TECHNICAL REVIEW OF ENVIRONMENTAL MONITORING REPORTS PREPARED BY DOE FOR TANK FARMS

Reviewers: Cynthia S Barr, U.S. Nuclear Regulatory Commission

Monitoring Documents Reviewed:

Figure 2 FTF Monitoring Well Locations (Image Credit: SRNS-RP-2017-00073, Rev. 0, Figure 4)

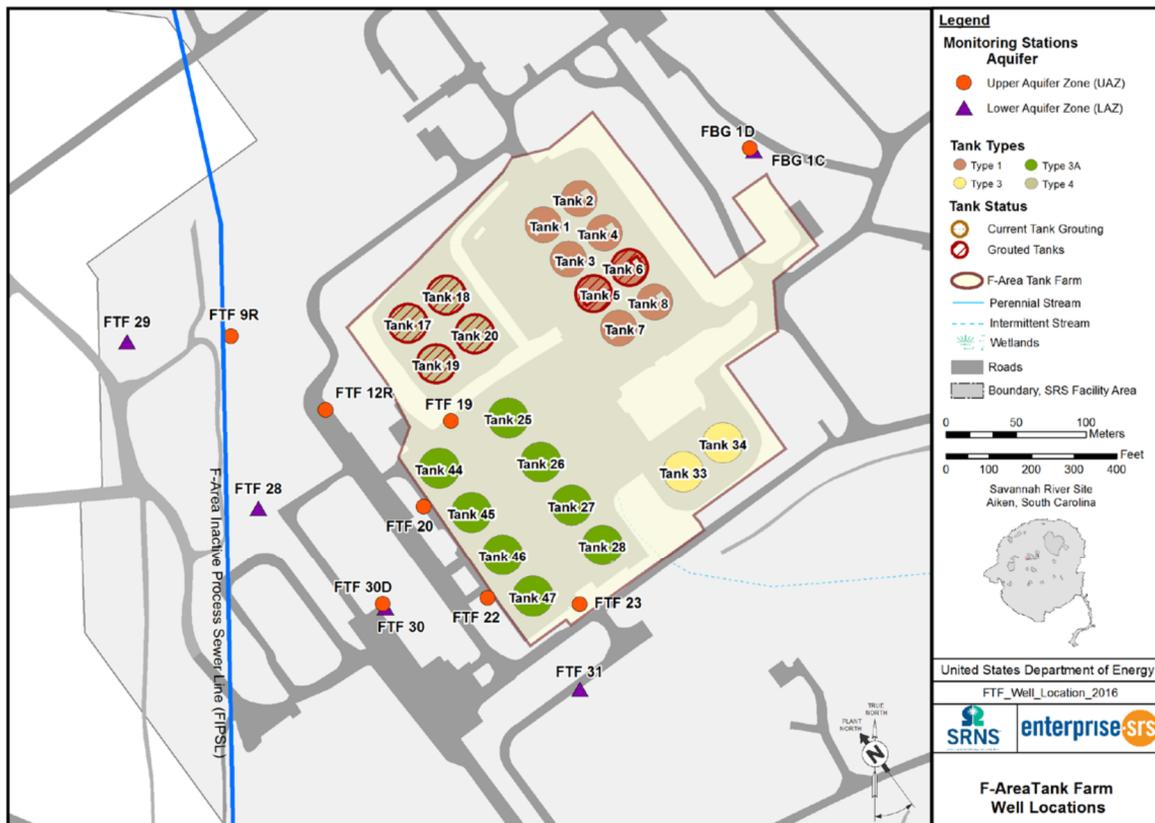
As stated in the previous technical review report evaluating tank farm monitoring (ML12272A124), NRC staff thinks that additional information is needed to support the conclusion that the elevated non-volatile beta and Tc-99 concentrations observed in well FTF 28 downgradient of the FTF is primarily associated with the FIPSL. FTF 28 is screened in the lower aquifer zone of the UTRA at an elevation of 151-161 ft (45-48 m). Nearby well FSL 5D, also depicted in Figure 4, is also thought to be impacted by the FIPSL; however, FSL 5D is located approximately 50 ft (15 m) higher in the upper aquifer zone of the UTRA. Although wastewater released from the FIPSL could have migrated towards FTF 28 in the vadose zone, it is more difficult to explain the vertical migration of the radioactivity to the lower aquifer zone of the UTRA (to well FTF 28) in such a short lateral distance from the source.

SRNS-RP-2017-00073, Revision 0, relies partially on depressed pH measurements to support its hypothesis that FTF 28 is impacted by acidic waste water suspected to have leaked from the FIPSL into the underlying subsurface. However, data for only a handful of wells (five) screened in the lower aquifer zone of the UTRA are presented for comparison. Well FTF 31 has a similar if not slightly higher average hydrogen ion concentration (lower pH) compared to FTF 28, and FTF 31 does not have elevated Tc-99. Furthermore, well FTF 12R (see Figure 2) screened in the upper aquifer zone of the UTRA is also impacted by elevated Tc-99 (250 pCi/L); however, this well has one of the highest pHs (pH of 6 and 6.5 in two sampling events) of the handful of wells (seven wells) where both pH and Tc-99 data are available in SRNS-RP-2017-00073. No explicit explanation for the source of Tc-99 at FTF 12R is provided. DOE should clarify the expected source of Tc-99 at FTF 12R.

As stated in the previous technical review report (ML12272A124), contamination of the lower aquifer zone of the UTRA at FTF 28 could have occurred during FTF 28 well construction due to leakage of Tc-99 from the overlying aquifer. Leakage from an overlying aquifer could provide a plausible explanation for the depth of contamination at this well. The release of Tc-99 from another source located further upgradient of the FIPSL is also another plausible explanation for the vertical extent of the Tc-99 plume near the FIPSL. Based on NRC staff's review of more recent data provided by DOE since the last technical review report, NRC staff continue to think that stronger support for the source of the plume at FTF 28 is needed. Additionally, there is no evidence that Tc-99 activity at well FTF 12R is sourced by the FIPSL. While FTF 12R may also be impacted by naturally occurring radionuclides (most of the nonvolatile beta activity observed at FTF 12R is attributable to Pb-214 and Bi-214), the presence of Tc-99 was not explicitly addressed in SRNS-RP-2017-00073. Backward particle tracking could help determine the potential source of Tc-99 at FTF 12R, and provide support for the source of the Tc-99 present at well FTF 28.

The maximum tritium concentration occurred at well FTF 30D at a value of 42.8 pCi/ml in September 2016. Upgradient of FTF 30D tritium concentrations were stated to be very low suggesting that the tritium at FTF 30D was not sourced by the Tank Farm. The screen depth of FTF 30D is 213 to 223 ft (64 to 70 m) and is expected to be higher than the centerline of any plume released from the F-Area tanks based on modeling (see Table A-1 and ML12272A124). Nonetheless, DOE does not present any information to explain the source of the tritium at this well. DOE should provide additional information regarding the source of the tritium at FTF 30D. Backward particle tracking could help determine the potential source for the tritium at well FTF 30D.

Background well FBG 1D has been dry and unable to be sampled in recent monitoring events. While water levels are considered close to their average long-term values, the inability to sample groundwater from well FBG 1D during close to average groundwater level years limits its utility as a background well. DOE should consider construction of a new background well(s) in the future to ensure quality data are able to be collected in the future.

Figure 7 HTF Monitoring Well Locations in Relation to Stream Traces from HTF Tanks Illustrated in the HTF Performance Assessment Figure 4.4-55. Adapted from Figure 4.4-55 in SRR-CWDA-2010-00128, Rev. 1.

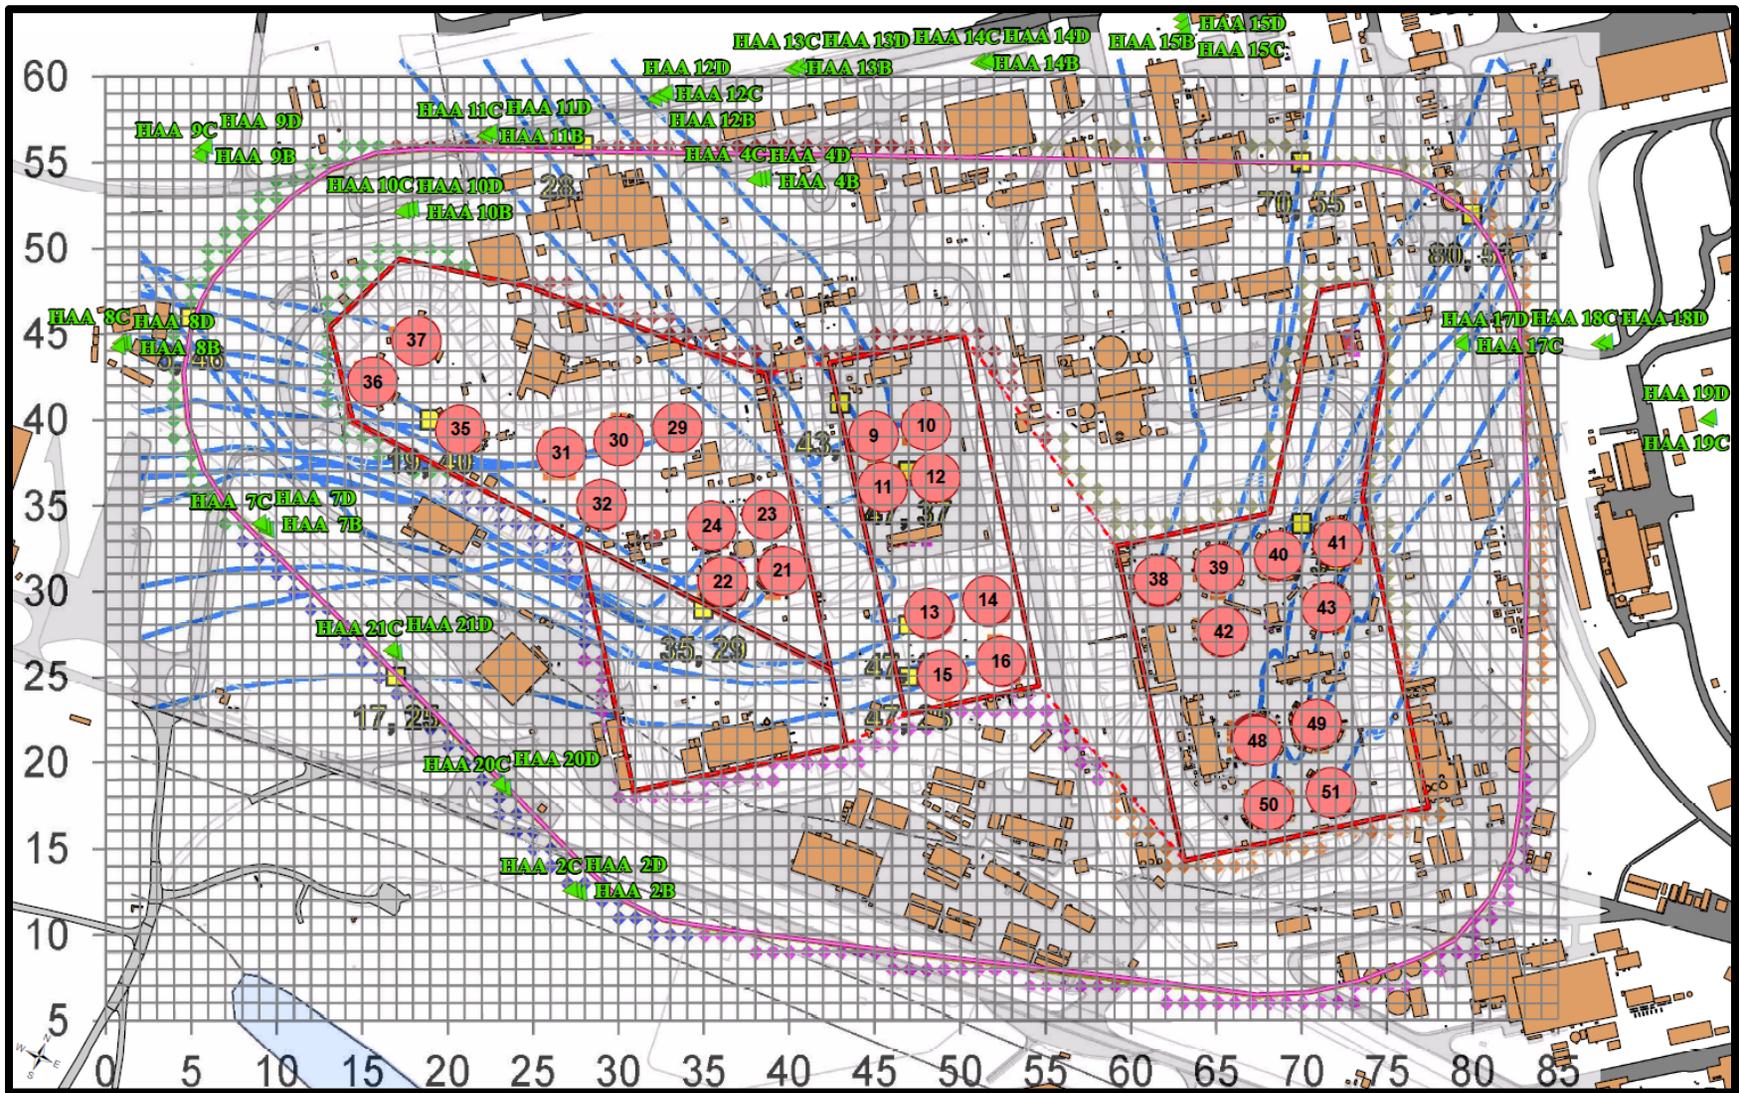
Based on NRC staff's evaluation, and similar to the NRC staff's findings for the FTF, NRC staff concludes that the HTF monitoring well network could be further optimized to help ensure releases from the HTF facility are detected. Table 1 lists each HTF well and provides an assessment of whether the well is screened at an appropriate depth in the aquifer to best detect releases from various sets of tanks (all sources, southern sources (Tanks 13-16, and Tanks 48-51), central sources (Tanks 21-24), and northern sources (Tanks 35-37, Tanks 29-32, Tanks 9-12, and Tanks 38-43)). The basis for placement of the HTF well screen intervals is unclear, as they do not always appear to be screened at the most appropriate depth based on the Performance Assessment (PORFLOW) saturated zone flow and transport model results when considering releases from tank sources (consideration of other FTF sources, hydrogeological, or other considerations may have influenced well screen placement). However, in general, NRC staff finds that many of the HTF wells are screened too high in the aquifer to detect HTF tank releases should they occur in the future, most notably for tank sources located to the south which travel a much further distance to the wells (plumes would typically be expected to be significantly lower than the HTF wells are screened in many cases). In the case of northern sources, some of the wells may be screened too deep. With regard to lateral placement of HTF wells, NRC staff also notes that there appears to be an area between HAA 15 and HAA 17 well series which may not have adequate coverage to pick up releases from certain eastern tank sources based on particle tracks depicted in Figure 7, which was reproduced from the HTF PA.

NRC staff suggests that when the monitoring well network is evaluated in the future, DOE contractors perform an evaluation using the HTF Performance Assessment (PORFLOW) model and provide input on the horizontal and vertical distribution of wells in the HTF monitoring network to DOE and its subcontractors. This effort should be focused on identifying well locations that would maximize the ability to detect HTF releases and minimize false negative monitoring well results. Adequate groundwater monitoring data could help provide support for Performance Assessment models and results, as well as provide direct evidence that the tank farm facilities are operating as intended. NRC staff will continue to monitor the basis for and adequacy of the HTF monitoring well network and field and chemical data collected, as tank farm closure progresses.

Figure A-1: Stream Traces from FTF Tanks, FTF Local Model Grid, and FTF Well Locations Assigned to Model Cells. Adapted from Figure 5.2-5, SRS-REG-2007-00002, Rev. 1.

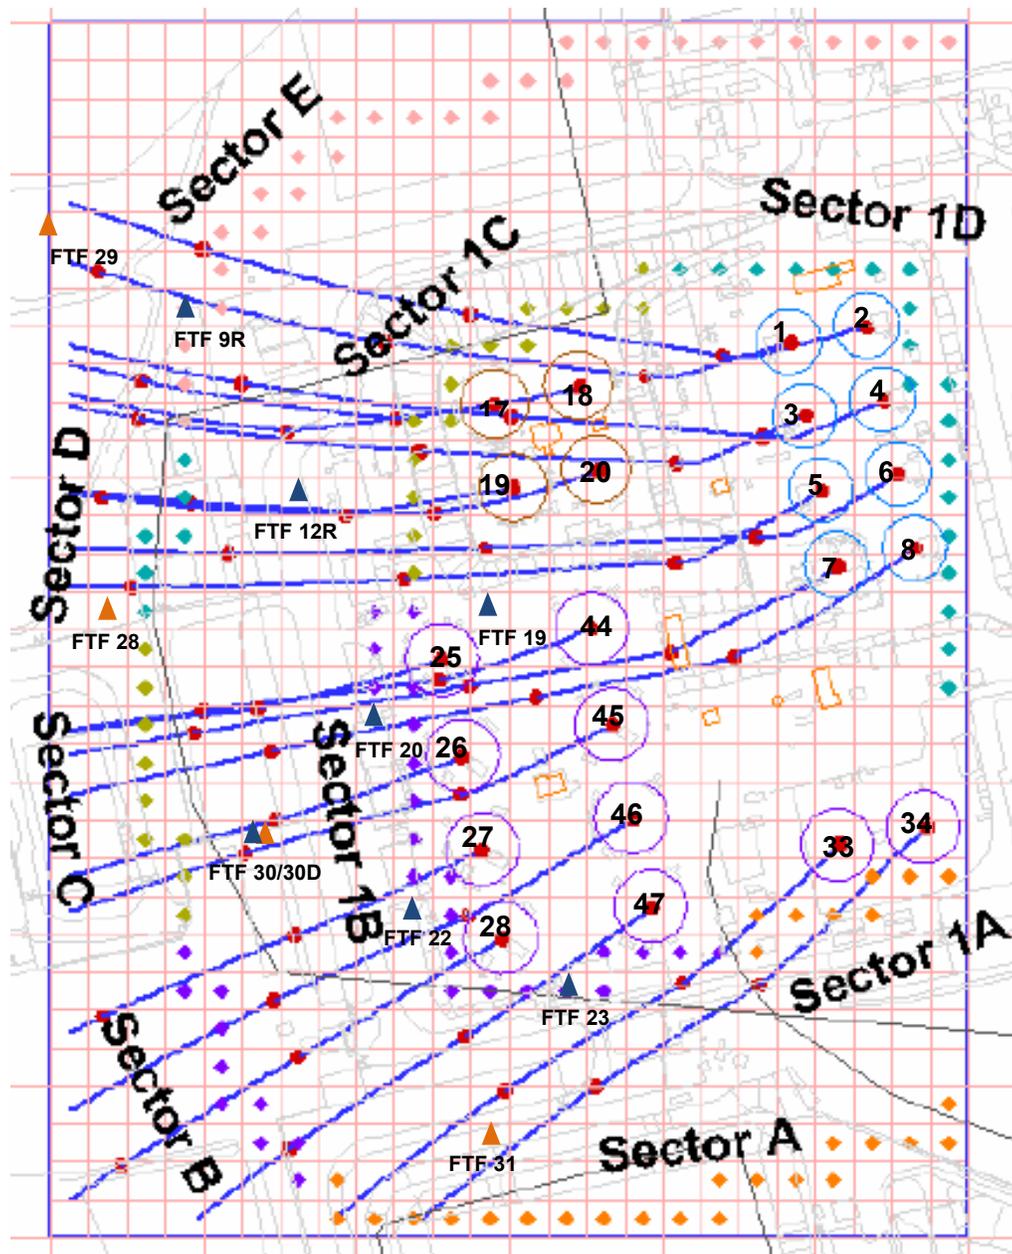
Table A-1 provides results of NRC staff's evaluation of the FTF monitoring well network documented in ML12272A124. Table A-1 indicates, based on PORFLOW modeling whether FTF wells are optimally placed to detect releases from "western sources" at the FTF (i.e., Tanks 17, 18, 19, 20, 25, 26, 27, 28, 44, 45, 46, and 47) and "eastern sources" at the FTF (i.e., Tanks 1, 2, 3, 4, 5, 6, 7, and 8). Figure A-2 illustrates FTF monitoring wells in relation to stream traces from FTF tanks taken from Performance Assessment modeling, which provides information to evaluate the lateral placement of FTF wells to detect releases from the FTF tanks.
